**ZONING AMENDMENT
& SUBDIVISION STAFF REPORT****Date: June 18, 2015****APPLICANT NAME**

Aaiden Place Subdivision

CONTEMPLATED USESubdivision approval to create 1 legal lot of record, and
Zoning approval to rezone the site from B-1, Buffer
Business District to B-2, Neighborhood Business District,
to accommodate future businesses.**It should be noted, however, that any use permitted in
the proposed district would be allowed at this location if
the zoning is changed. Furthermore, the Planning
Commission may consider zoning classifications other
than that sought by the applicant for this property.****TIME SCHEDULE
FOR DEVELOPMENT**

SITE PLAN

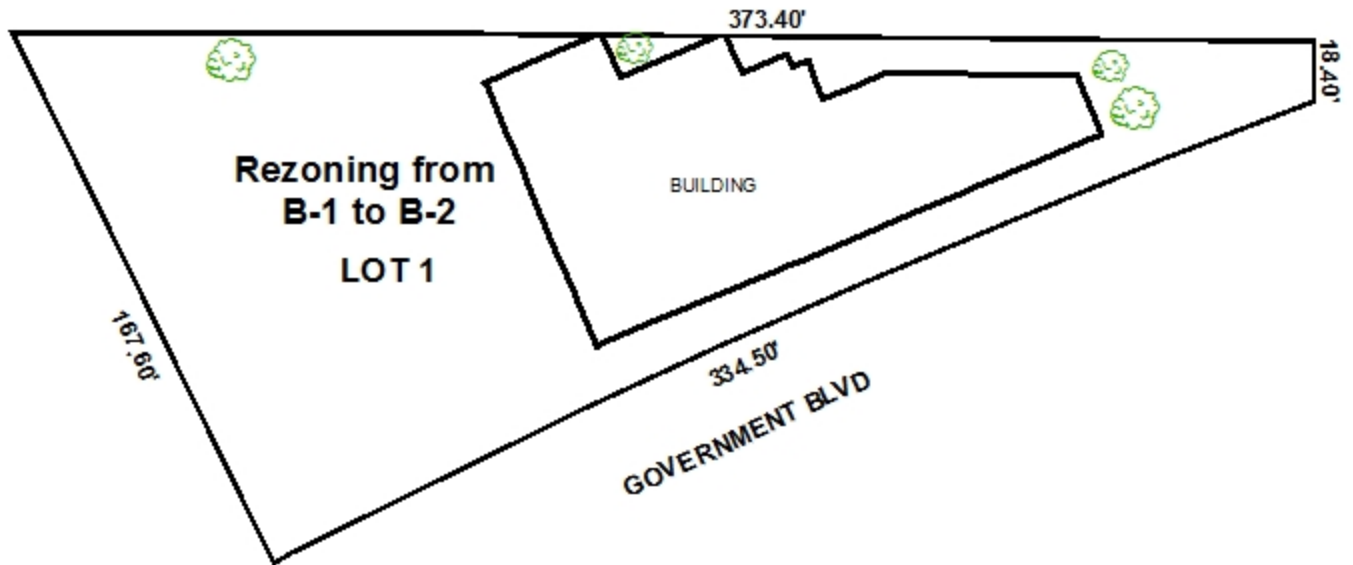
It should be noted that the site plan submitted does not accurately reflect the existing conditions on the site and is missing information. The site plan appears to be to-scale, but the scale is not provided. If approved, the site plan should be revised to state the appropriate scale.

The site plan illustrates 22 parking spaces, but the parking spaces are either not to scale or are not the required minimum size of 9' wide by 18' long. While the applicant does not provide the building size, it appears to be approximately 8,158 square feet, which would require a total of 27 parking spaces for office and retail uses. It also appears based on the site plan provided and aerial photos of the site that the parking spaces may be partly in the right-of-way, with all maneuvering areas located in the right-of-way. There appears to be a large paved area on the Western portion of the site that is not illustrated on the site plan, but could provide parking and maneuvering areas for the site on private property.

No mention is made on if the site will utilize a dumpster or curb-side pickup. The site plan should be revised to either include a note stating that curb-side pickup will be utilized or illustrate a dumpster enclosure with sanitary sewer connection compliant with Section 64-4.D.9. of the Zoning Ordinance.

Because the site is adjacent to R-1, Single Family Residential to the North, a residential buffer compliant with Section 64-4.D.1 of the Zoning Ordinance should be provided. The site plan does not make any mention of if a residential buffer exists, or is proposed to be erected. If approved, the site plan should be revised to meet this requirement. It should be noted that Section 64-4.D.1. of the Zoning Ordinance requires a 10' protection buffer between residentially zoned properties, and the existing structure appears to touch the property line adjacent to residentially zoned properties to the North.

The site plan provided does not mention the amount of total and frontage landscape area provided. The applicant did illustrate the locations of four existing trees on the site larger than 24" in diameter, but there is no mention of the tree species, or their exact size.

DETAIL SITE PLAN

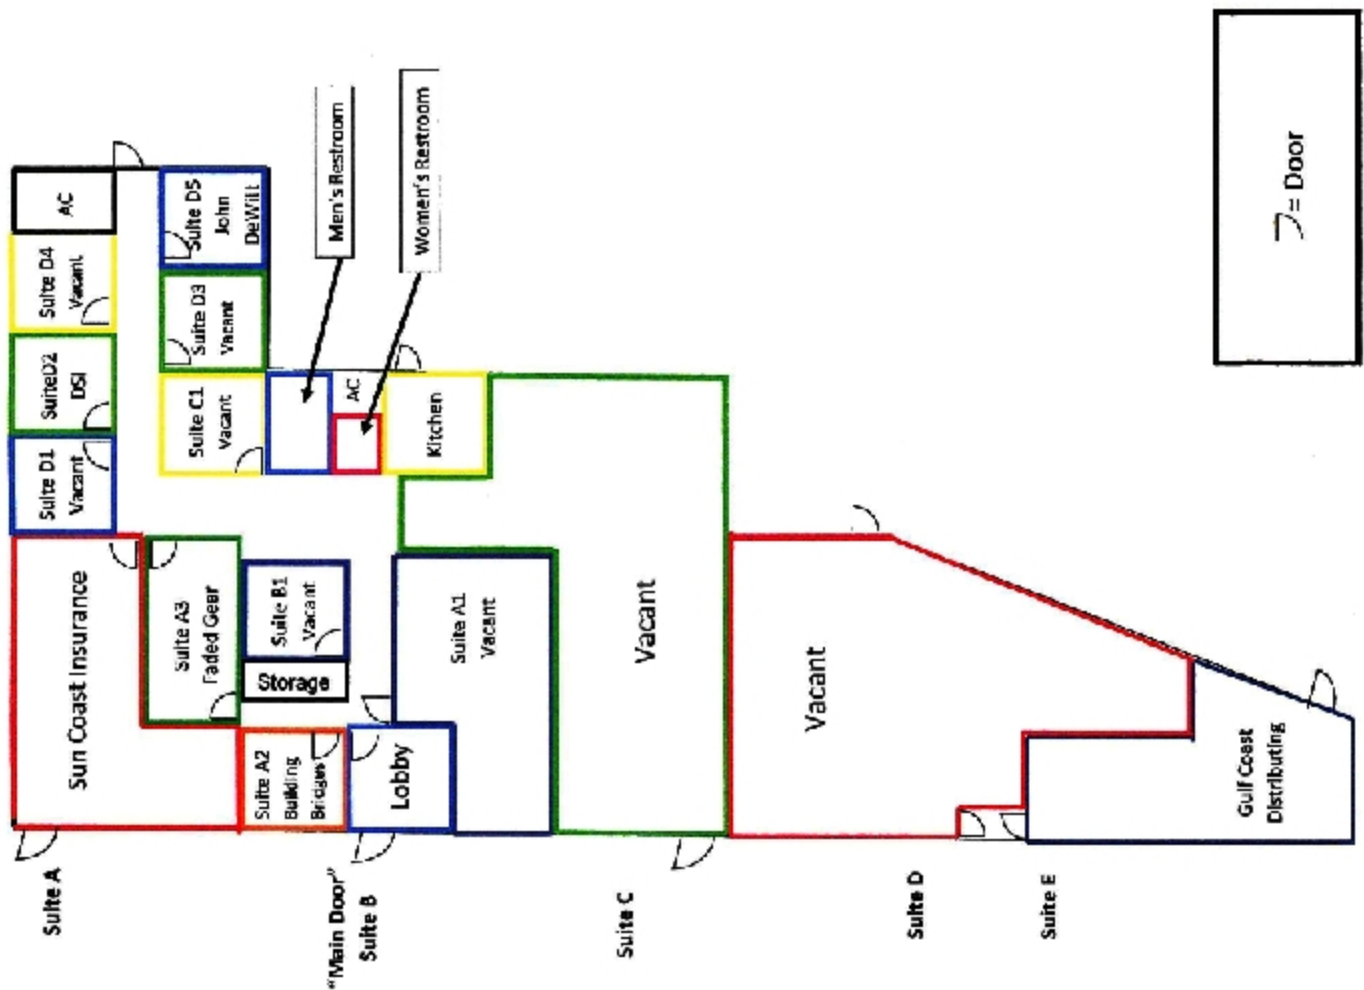
Similar to the site plan submitted for the rezoning request, the preliminary plat submitted with the Subdivision application appears to be missing information including, the scale of the drawing, signature blocks for the property owner and necessary city departments, and a North arrow. Also, it appears that on the Subdivision application, the applicant lists an engineer, however the individual named does not currently have a valid engineers license in the State of Alabama, and when staff questioned the listed "engineer" regarding the proposed project, he stated that he is not involved in the subject project in any way.

The preliminary plat submitted does not provide the lot size in square feet or acres, and it should be noted that the proposed lot exceeds the minimum required lot size in Section V.D.2. of the Subdivision Regulations. The lot size should be provided on the Final Plat in square feet and acres, if approved.

The site fronts onto Government Boulevard, a major street according to the Major Street Plan component of the Comprehensive Plan, and an ALDOT facility. The right-of-way width should be 250 feet, according to the Major Street Plan. The preliminary plat does not state what the current right-of-way width is at this location. It appears the existing right-of-way may be 230' at this location, which typically would require dedication. However, requiring dedication for this site would only exacerbate the amount of existing parking and maneuvering areas in the right-of-way. With this in mind, a waiver of Section V.B.2. of the Subdivision Regulations may be appropriate, in favor of an increased setback line so no future structures are erected in the future right-of-way. The 25-foot minimum building setback is not depicted for the proposed lot, and should be illustrated to provide 150' from the centerline of Government Boulevard on the Final Plat, if approved.

- 1) provision of the scale of the plat;

- 2) provision of a North arrow;
- 3) provision of signature boxes for the property owner and various city departments;
- 4) illustration of the minimum building setback line along Government Boulevard to provide 150' from the centerline;

- 5) provision of the lot size in square feet and acres;
- 6) revision of the plat to illustrate the right-of-way for Government Boulevard;
- 7) placement of a note on the plat stating that the lot should be limited to the existing curb cuts to Government Boulevard with changes in the size, location and design to be approved by ALDOT and Traffic Engineering and conform to AASHTO standards;
